Planning Submission For: (Strata Plan 67851) 'Marquis Apartments' at 200 William Street, Woolloomooloo.

Submission #2 - Revised Plans and Documents

Concept DA Proposal: D/2022/139 - 164-172, 174-194 William Street WOOLLOOMOOLOO NSW 2011 - 'Stage 1 concept proposal for a mixed-use development including a concept envelope up to a height of approximately 35m (RL59.99), indicative future residential and retail land uses, vehicular and loading access from Forbes Street, 4 indicative basement levels for parking, services and storage as well as provision of a publicly accessible through-site link off Dowling Street that connects to Judge Lane and Forbes Street.' (revised)

By fjmt Studio Design Report – Proposed Montage showing the height of building relative to lower surrounding housing and forms &196-200 William Street directly to the top left and over scaled.

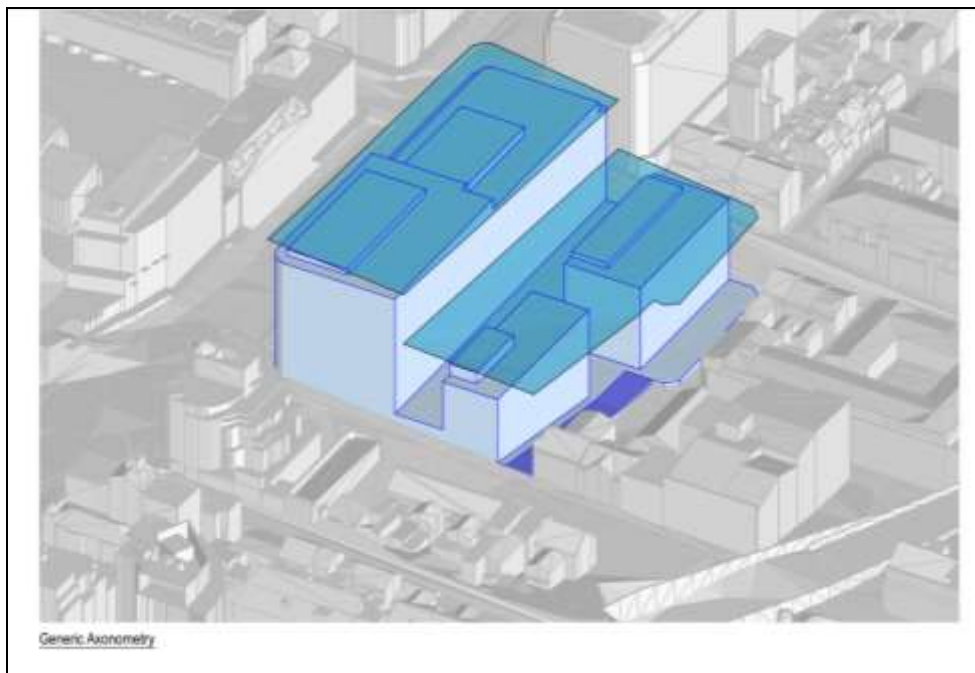
As detailed, the height is not considered appropriate to the condition of the site AND its context and does not provide transitions to the adjoining development or context. The scale would be incongruous.

A height of 22.6m in Judge Lane next to 12m height does not provide a transition.

This can be seen in the montages provided of the reference scheme ‘filling in’ the proposed envelope. This photo montage which looks down from a sky view to the proposed enormous building indicates the stark and incongruous height differences with lower prevailing forms. This graphic also shows the Marquis/Avis building dwarfed – to the top left. It is clear that the balconies and open spaces of the Marquis Apartments are directly impacted by the scale and block effect opposite.

Relative scales/Dowling Street, including heritage character forms.
Source: Submitted fjmt Studio Design Report - for DA -page 15.

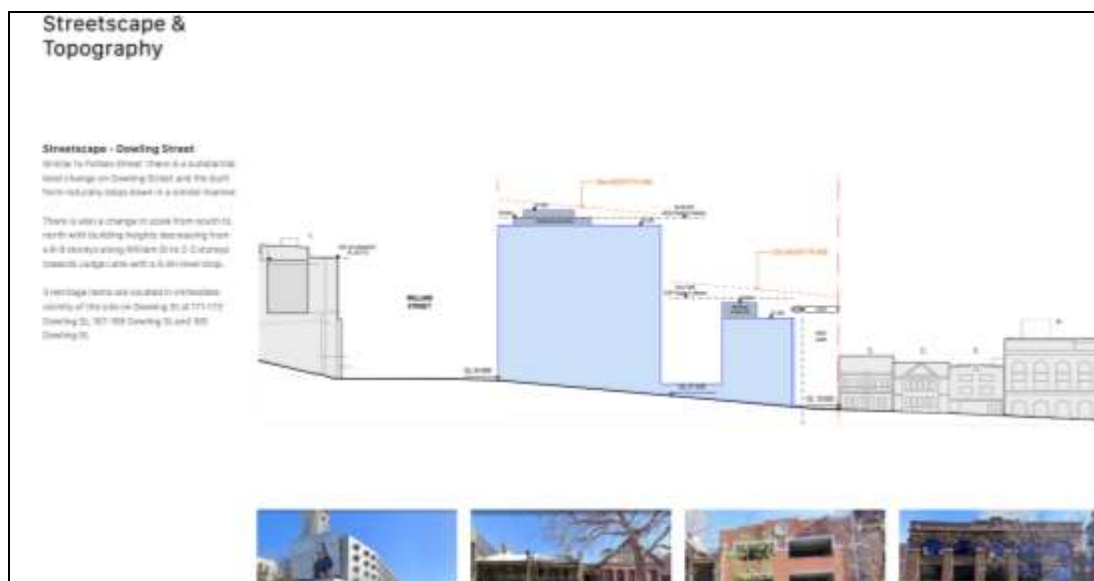
Extracts from the DA package/Design Report showing the height and scale of the form in the context of the much lower forms. The Avis residential building, shown bottom left corner is dwarfed. No detail is provided in the documentation as to what if anything this version does to any views from balconies.
